Office Action Summary

10/517,458

JOHNSON ET AL.

DETAILED ACTION

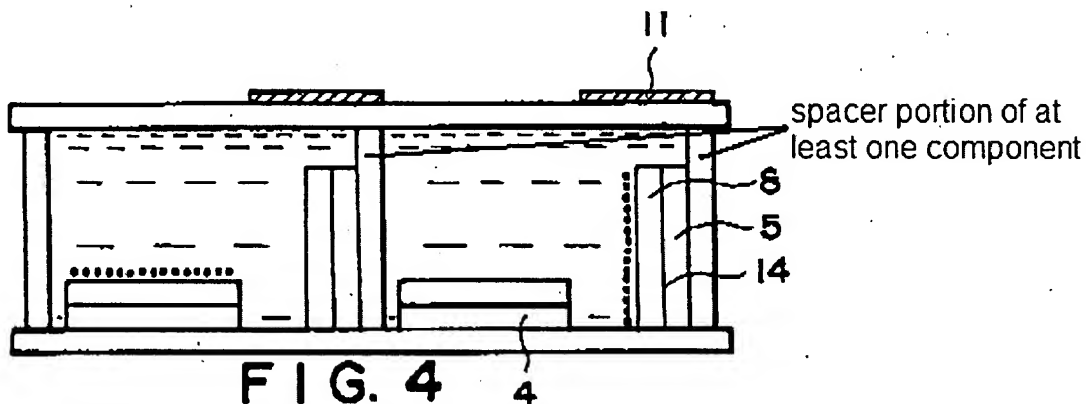
- a) With respect to claim 1, Kishi et al. discloses a display device in Figure 3 comprising of a pixel being provided with an one individually addressable pixel obstructing element (Figure 4, item 11), characterized in that a portion of at least one component (see below figure), being one of spacer or an electrical component other than an electrode, is positioned beneath the obstructing element (item 11) in such a way that the portion is not visible for a viewer of the display device (column 4, line 59-67 – column 5, line 12).

- b) With respect to claim 2, Kishi et al. further discloses wherein the at least one component is spacer (see figure above).
- c) With respect to claim 5, Kishi et al. further discloses wherein the device is an electrophoretic display device.
- d) With respect to claim 9-11, Kishi et al. further discloses wherein a portion of both of the spacer (see figure above) and the electrical component are positioned beneath the obstructing element; wherein a portion of two electrical components are positioned beneath the obstructing element; wherein portion of an electrode (figure 4, item 5) is positioned beneath the obstructing element (figure 4, item 11).

Applicant argues that "a portion of at least one component, being one of spacer or an electrical component other than an electrode" (Remark, page 7). The current rejection with the same reference with a spacer is pointed out in figure above.

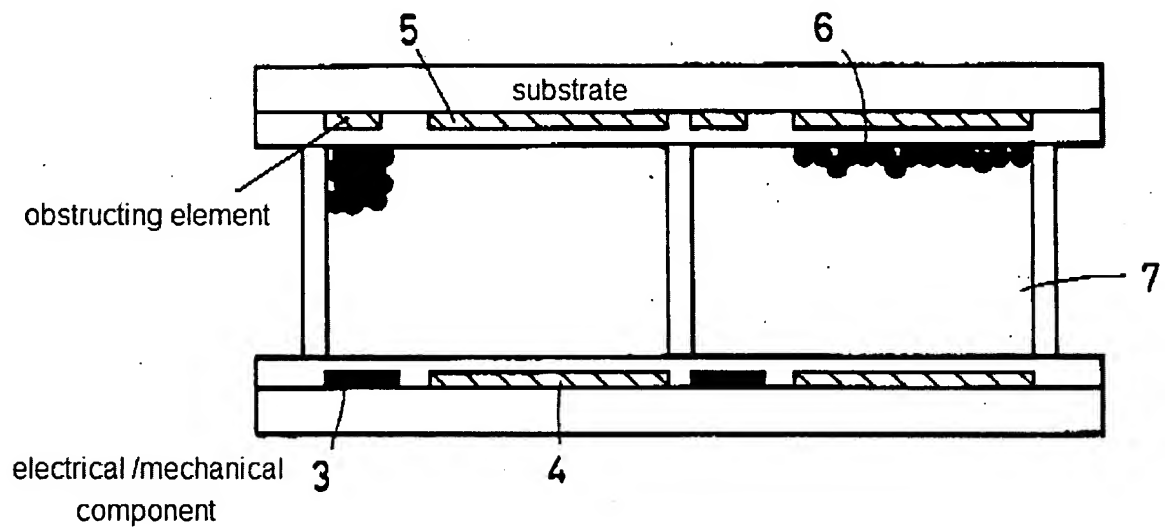
However, Kishi et al. do not teach a reflective element for enabling transfective operation. Within the same field of endeavor, Goden discloses the obstructing element is arranged behind a front substrate (see picture below).

It would have been obvious, therefore, at the time the invention was made to a person having skill in the art to construct the display device such as disclosed by Kishi et al., and with the obstructing element is arranged behind a front substrate such as discloses by Goden, for purpose of reflecting light.
